Full Blast Federal Com #1 1650' FSL & 660' FEL Section 18, T25S, R26E Eddy County, New Mexico

# PECOS DISTRICT CONDITIONS OF APPROVAL

OPERATOR'S NAME:	MARBOB ENERGY CORPORATION	
LEASE NO.:	NMNM-94589	Same of the
WELL NAME & NO.:	1 – FULL BLAST FED COM	
SURFACE HOLE FOOTAGE:	1650' FSL & 660' FEL (Ut I) NE SE	
BOTTOM HOLE FOOTAGE	Same	•
LOCATION:	Section 18, T. 25 S., R26 E., NMPM	
COUNTY:	Eddy County, New Mexico

Figure 1 - Cross Sections and Plans For Typical Road Sections

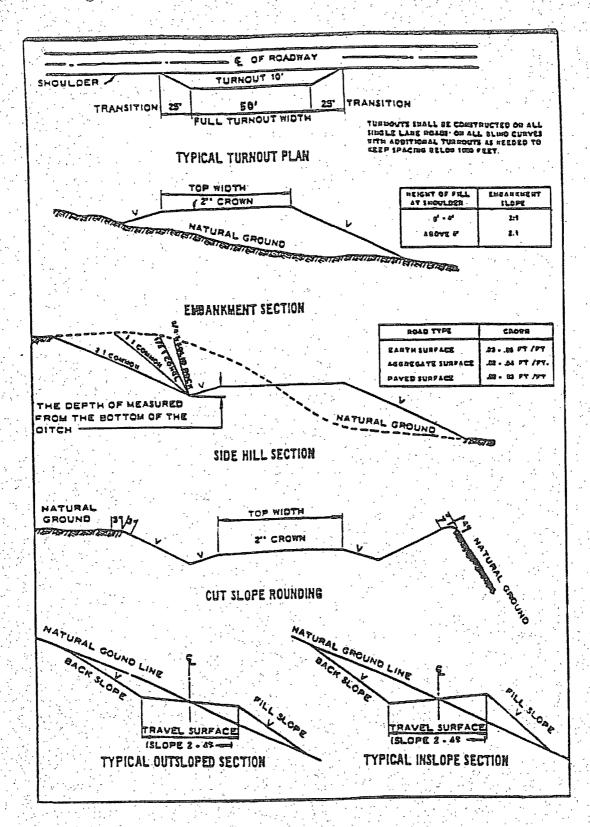
Crowning shall be done on the access road driving surface. The road crown shall have a grade of approximately 2% (i.e., a 1" crown on a 14' wide road). The road shall conform to Figure 1; cross section and plans for typical road construction.
